# STAFF RECOMMENDATION

NCPC File No. 7216

## PENTAGON RESERVATION CORRIDORS 2 AND 3 PEDESTRIAN SCREENING FACILITIES

February 24, 2011

### PROPOSED SCREENING FACILITY - AXONOMETRIC

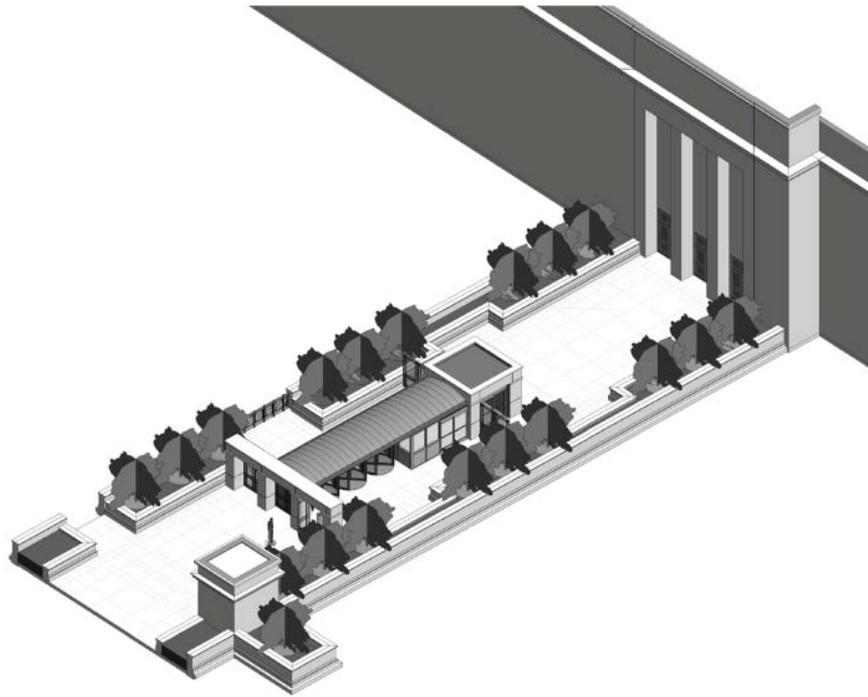
**Staff finds that through consultation with NCPC and CFA the designs for the Corridor 2 and 3 pedestrian screening facilities have improved and appreciates the applicant's willingness to address concerns raised over the past few months.** The proposed design is a complementary site element that fits well within the historic context of the Pentagon without calling attention to itself as a functional screening facility. The use of similar building materials

and colors as well as the use of gates and turnstiles enables this element to accomplish both the aesthetic goal of blending into its setting and the functional goal of screening employees and visitors alike.

The Commission of Fine Arts approved the concept design for the new pedestrian screening facilities for Corridors 2 and 3 at its January 20, 2011 meeting. CFA also recommended that the applicant clarify the relationship of the entrance portal structures to the Pentagon and suggested the applicant consider limestone rather than cast stone and use masonry detailing to reflect the language and profiles of either the Pentagon or the existing bridges.
